# SITE QUALITY REVIEW

**Garraby Mews, Victoria Way,  
Carlisle, CA2 5NP**

<b>Site Reference:</b>	PL-LABC-1959759
<b>Builder:</b>	Smith's Builders plc
<b>Developer:</b>	Rutland Homes Ltd
<b>Site Manager:</b>	John Smith

<b>Auditor:</b>	Mr Antal Poor
<b>Date of Inspection:</b>	02/03/2023
<b>Auditor Email:</b>	antal.poor@mdwis.co.uk
<b>Contact:</b>	07855548362

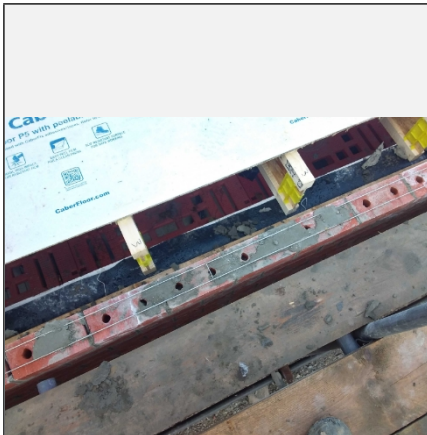
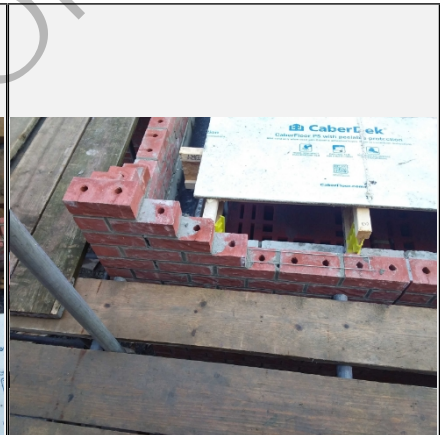
DESCRIPTION	SEVERITY	PLOTS AFFECTED
Reinforcement is being installed to the brickwork as per design <b>Images: 1, 2, 3, 4</b>	Industry Standard	Plot 258 - Plot 259
The external leaf walling has been constructed using Persimmon Gen3 concrete bricks. The perpendicular and longitudinal joints are generally uniform and have good alignment and shape corners <b>Images: 5, 6, 7</b>	Industry Standard	Plot 258

1) Plot 256 -

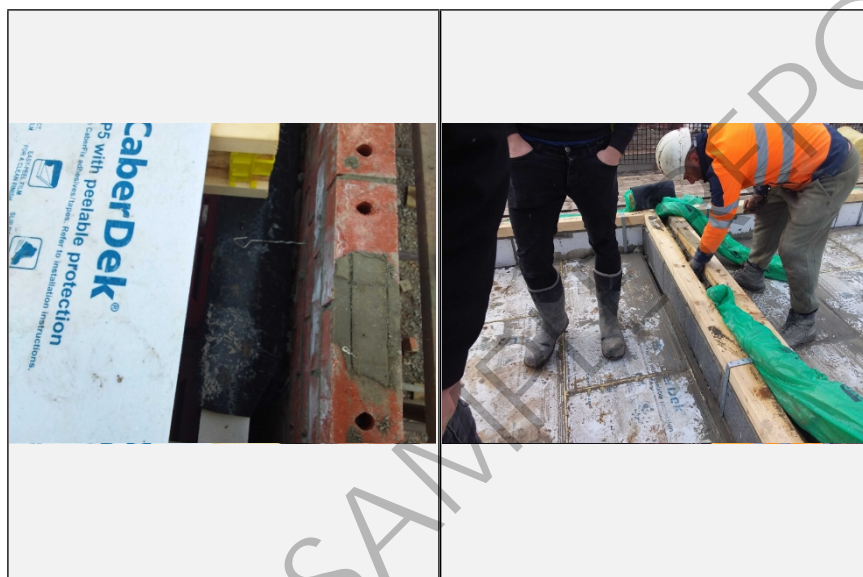
DESCRIPTION	SEVERITY	PLOTS AFFECTED
<p>Cavity to party wall had mortar present upon the accoustic insulation. The site manager instructed the brickwork contractor to clean immediately</p> <p><b>Images: 1</b></p>	Poor - Risk of Claim	Plot 256

DESCRIPTION	SEVERITY	PLOTS AFFECTED
Cavity trays have been installed correctly, turned up at the ends with weepholes in place <b>Images: 1</b>	Industry Standard	Plot 259
Under the instruction of the Site Manager the bricklaying contractor returned to the plot to clean the party wall cavity <b>Images: 2</b>	Industry Standard	Plot 256

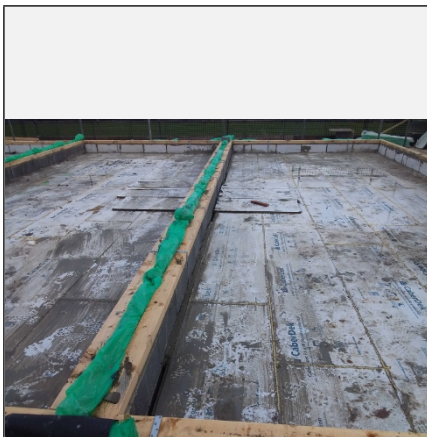
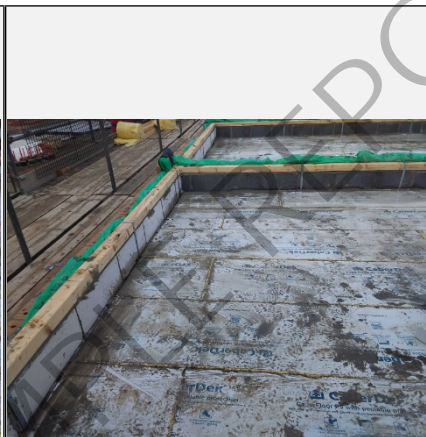
DESCRIPTION	SEVERITY	PLOTS AFFECTED
Fire stopping is in place closing all cavities awaiting the spandrel installation <b>Images: 1, 2, 3</b>	Industry Standard	Plot 256
The partywalls have been filled using accoustic insulation with 300mm fire socks in place to the party wall junctions <b>Images: 4, 5</b>	Industry Standard	Plot 259

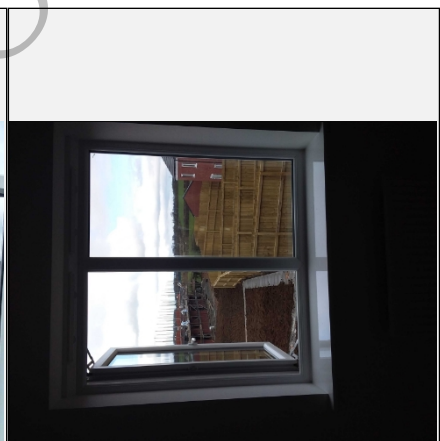
DESCRIPTION	SEVERITY	PLOTS AFFECTED
The UPVC window formers have been installed with ties to securely connect to the brickwork with added insulation to the reveals to prevent any chance of cold bridging. <b>Images: 1, 2</b>	Industry Standard	Plot 258
Means of escape windows have been installed to every first floor habitable rooms, within this 2 storey detached plot <b>Images: 3</b>	Industry Standard	Plot 265

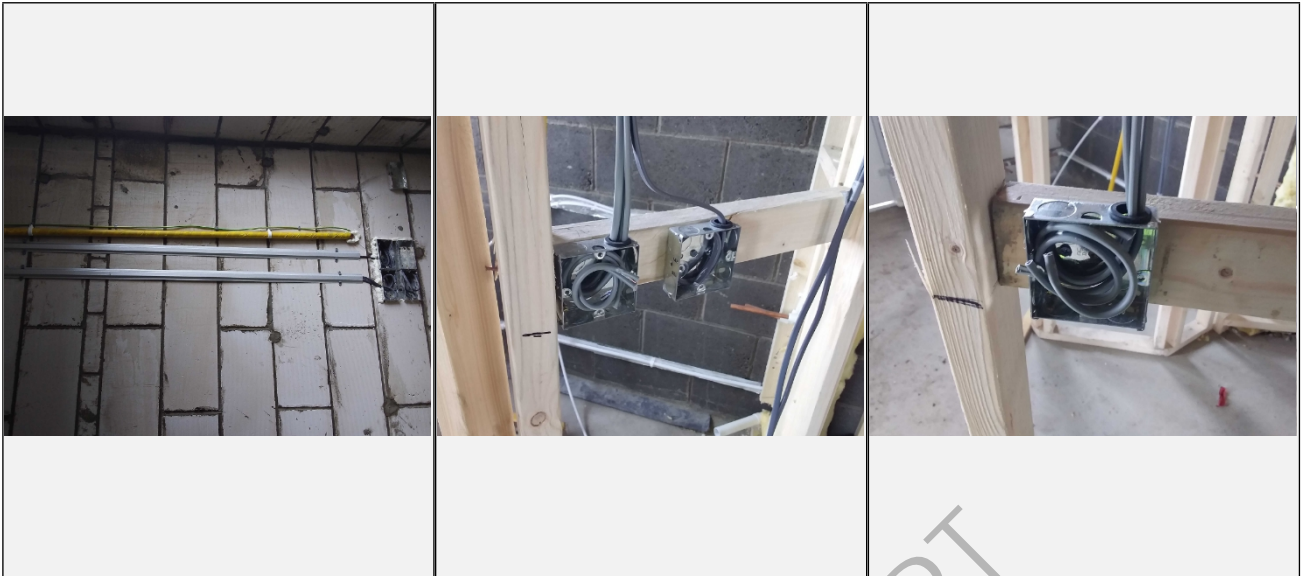
DESCRIPTION	SEVERITY	PLOTS AFFECTED
Missing grommits to a small number of the metal socket backboxes where wiring transfers through <b>Images: 1, 2</b>	Major Non Compliance	Plot 265

The electrician is to fit rubber grommits to all metal socket backboxes.

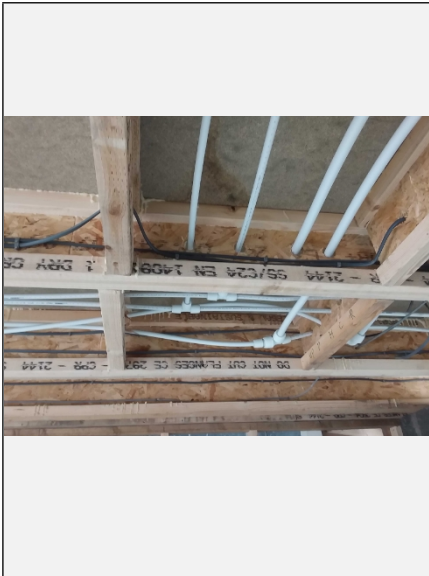
DESCRIPTION	SEVERITY	PLOTS AFFECTED
Pipe runs located upon solid walls have been installed upon foil backing tape for detection purposes <b>Images: 1</b>	Industry Standard	Plot 261
The internal soil stack has been wrapped fully around using insulation for accoustic purposes. To improve please consider using tie wraps or similar to secure in place <b>Images: 2</b>	Industry Standard	Plot 261
The drill holes for pipework to pass through have been carried out to the manufacturer's requirements. Off cuts of joists have been used as noggins to support the pipework between joists <b>Images: 3, 4</b>	Industry Standard	Plot 261
